**TOWN OF MOUNTAIN VILLAGE
DESIGN REVIEW BOARD REGULAR MEETING
THURSDAY FEBRUARY 5, 2015, 10:00 AM
2nd FLOOR CONFERENCE ROOM, MOUNTAIN VILLAGE TOWN HALL
455 MOUNTAIN VILLAGE BLVD, MOUNTAIN VILLAGE, COLORADO
AGENDA
REVISED**

**COMMUNITY DEVELOPMENT DEPARTMENT
PLANNING DIVISION**

250A Remodel
Mountain Village, CO

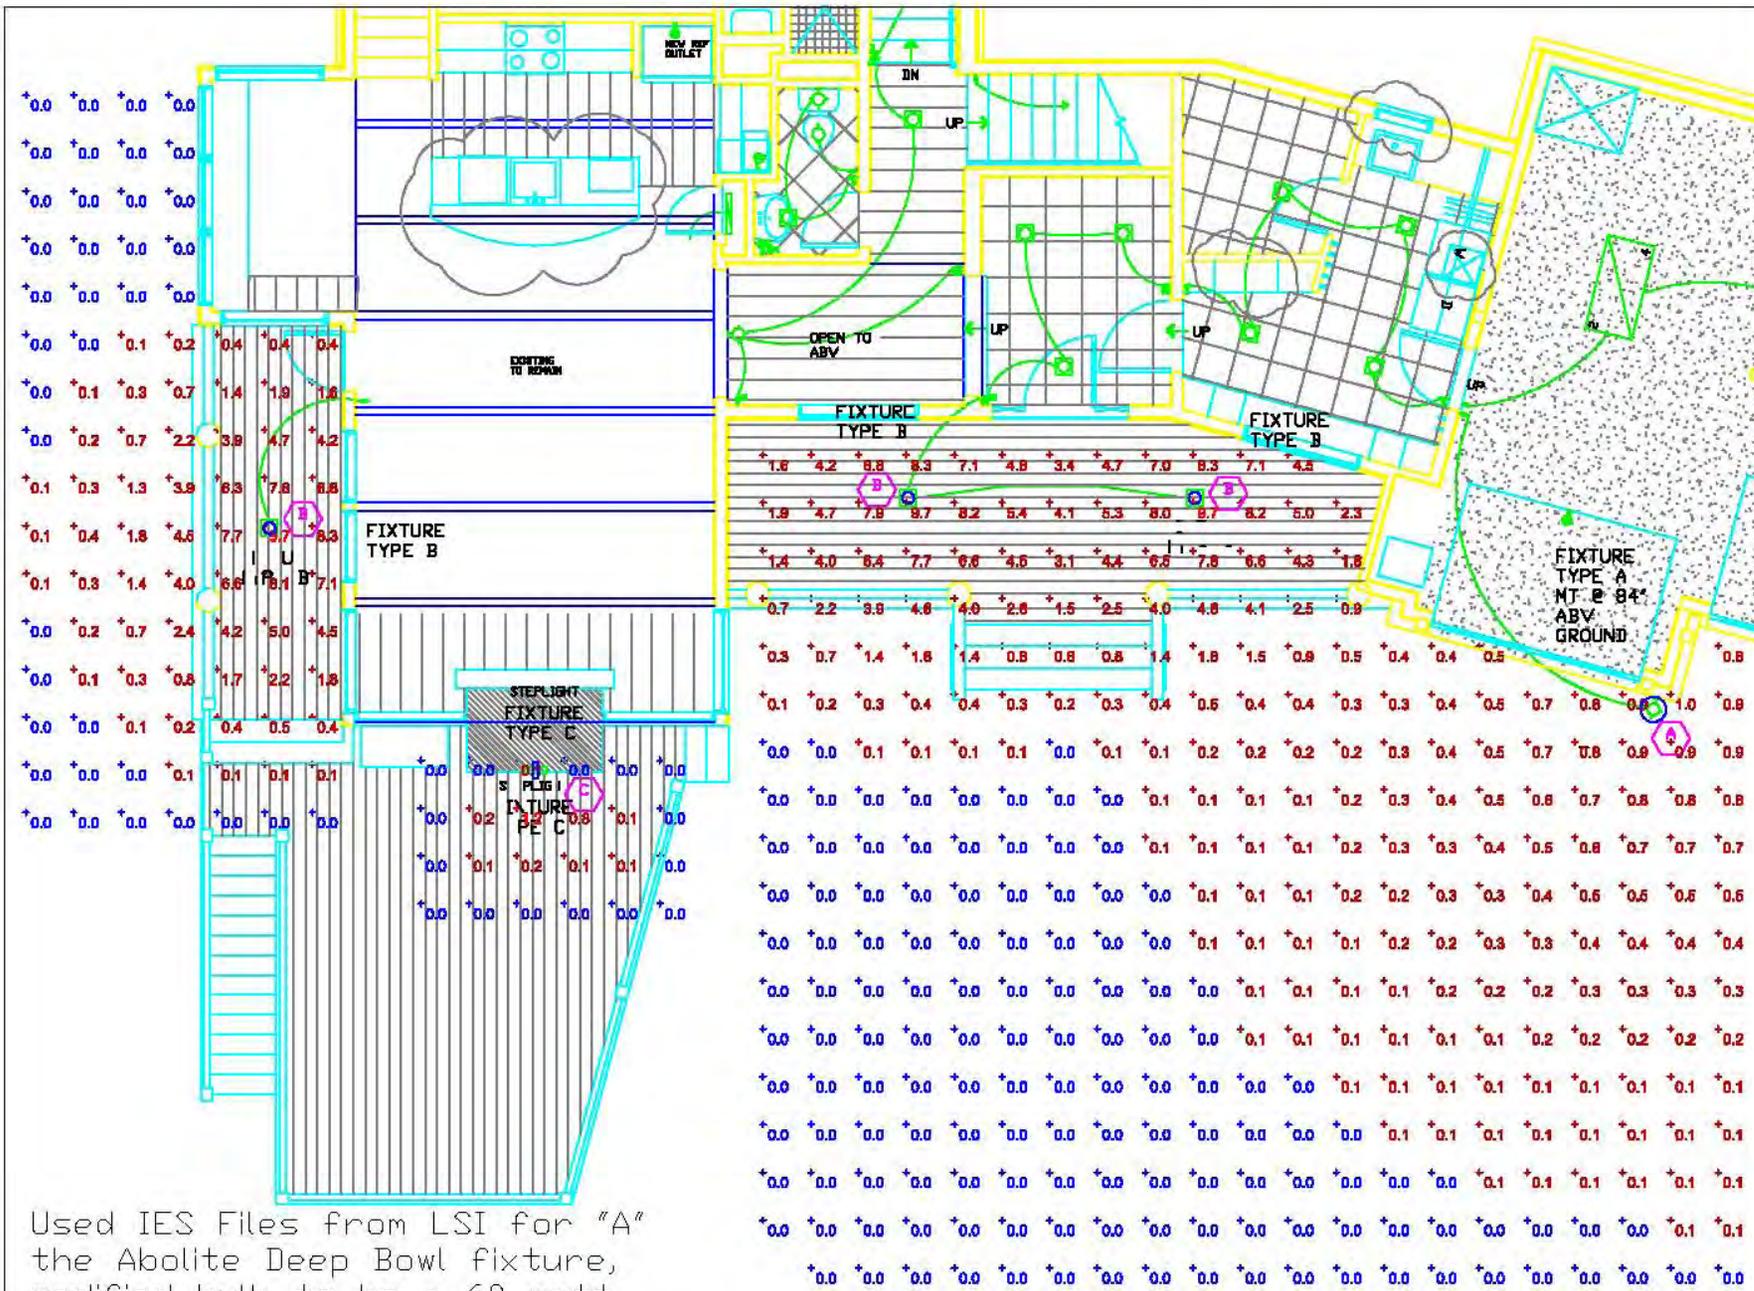
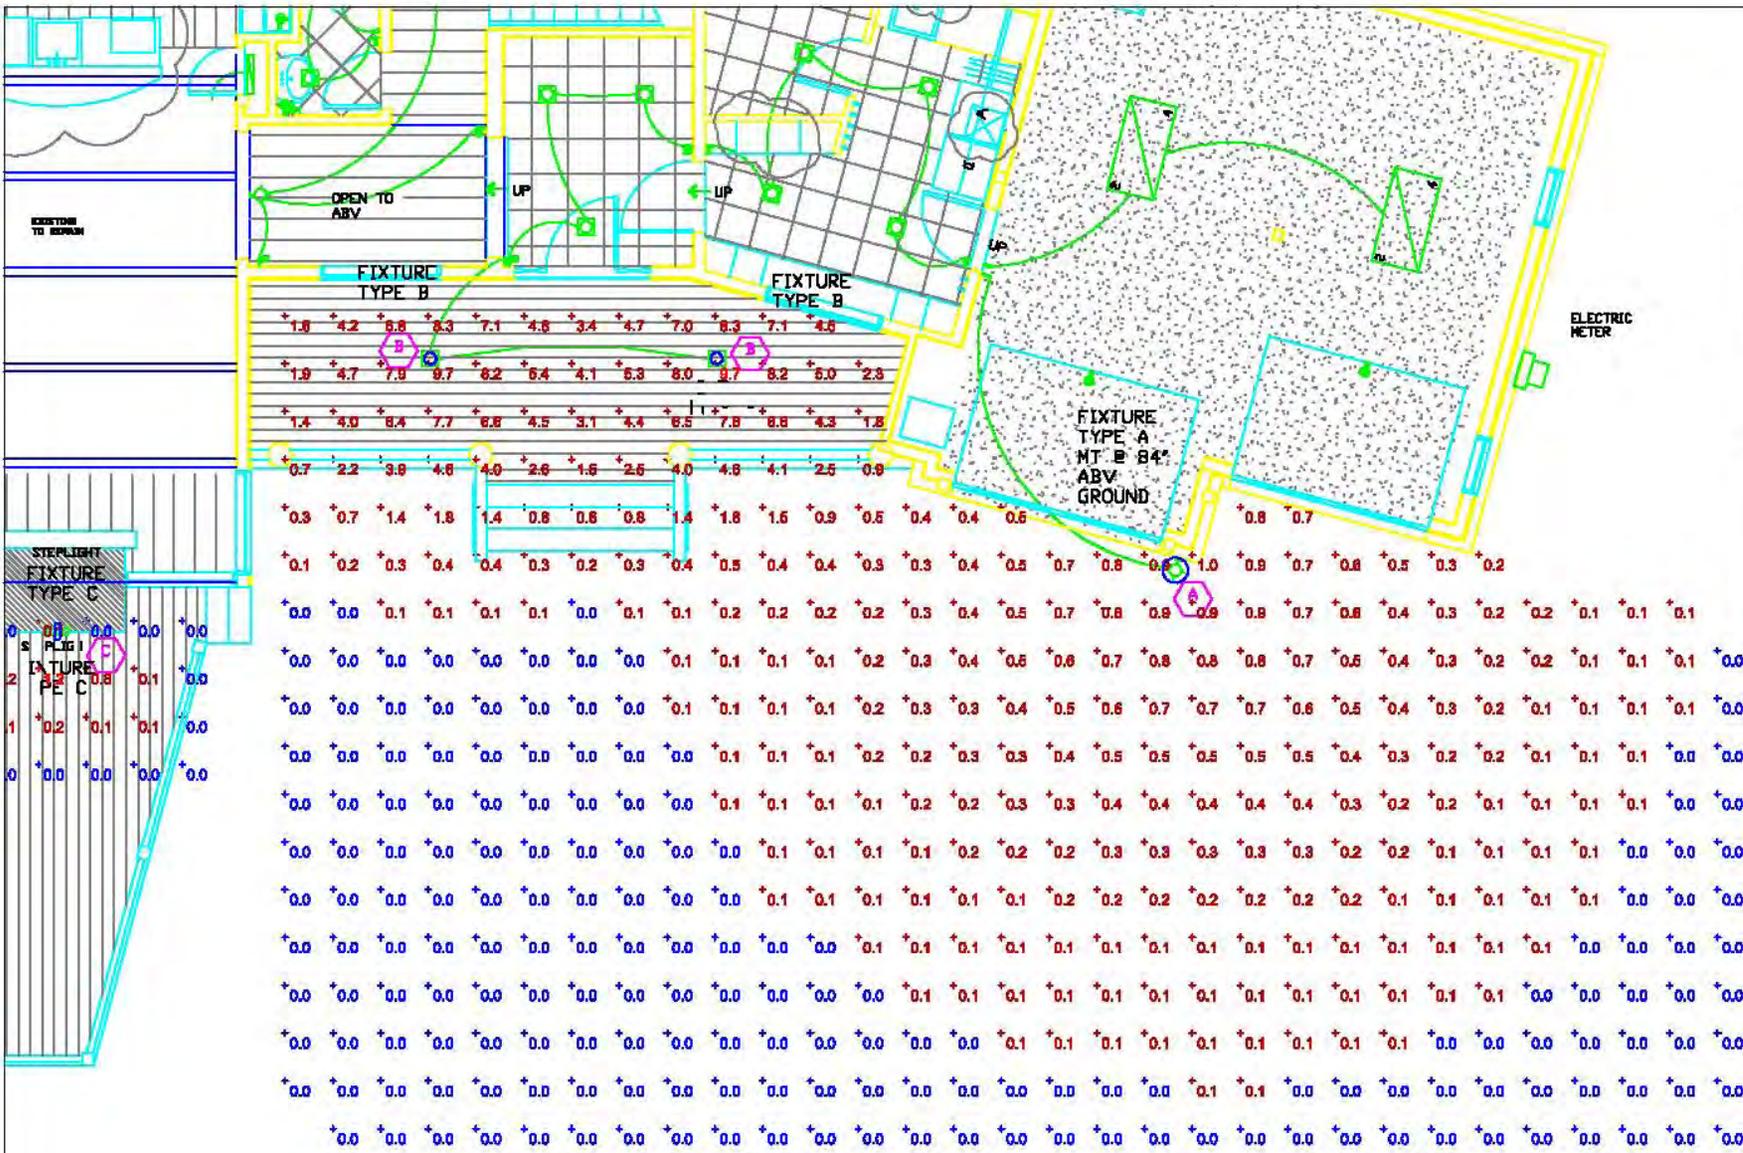
The proposed lighting plan will need to be revised to specify an LED bulb for the Type A fixture since bulb options are available. The revised cut sheet will need to specify the temperature of the LED light. The LED bulb temperature also has to be specified for the Type B and Type C fixtures consistent with the Lighting Regulations. Staff has added a condition to address these needed revisions.

7. Prior to issuing a development permit, the lighting plan shall be revised to specify an LED bulb for the Type A fixture and the associated specifications; and also specify the LED bulb temperature for the Type B and Type C fixtures.
